**Addendum for Invitation for Bids
Storybook Reading Room Addition to the Lynchburg Public Library**

13-847

Date: 6/19/2013
From: Lisa Moss, Buyer VCA
RE: Addendum No. 2

ADDENDUM NO. 2**Main Library Storybook Room Addition – Lynchburg
Lynchburg, VA****TO ALL BIDDERS:**

By: M. PHILLIPS	Date: 06/17/2013	Proj. No.: 12010	Rev: 0	SK No.: SK-M2-001
Client: CITY OF LYNCHBURG				DWG No.: M2
Project: STORYBOOK ROOM ADDITION				Scale: NTS
Subject: PROTECTIVE UNDERGROUND CONDUIT & REFRIGERANT LINES				Page: 1 of 1

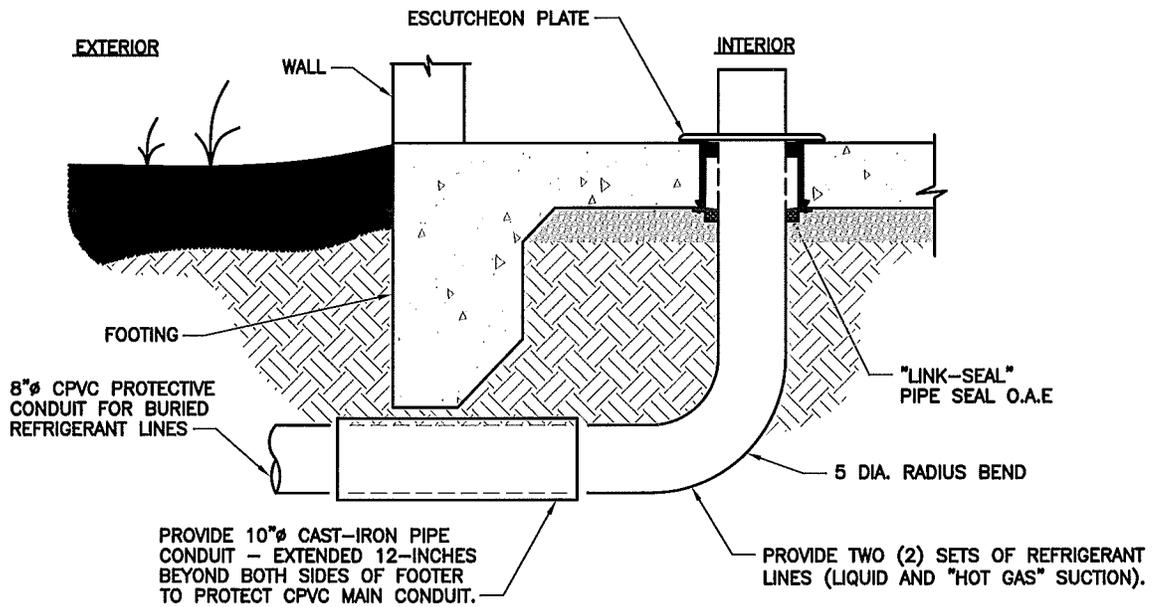
1. Sheet M2, note 4 it refers to an 8" pipe for refrigerant lines. It also refers to 3 sets of refrigerant lines in 3 – 4" pipes. Only 2 outdoor units are shown. Which one is intended for use?
Response: CPVC underground conduit shall be 8-inch diameter. Detail "5" on Sheet M2 has been modified to indicate the provision of "two (2) sets of refrigerant lines". See attached sketch SK-M2-001.
2. Are the sound baffle kits referring to outdoor or indoor units?
Response: Trane indicated that they can provide custom "sound baffle kits" for the indoor air handling units, on the returns to cut down on the fan noise that may work back toward the return openings.

Sheet M2: Refer to Attached Sketch SK-M2-001 for revisions.
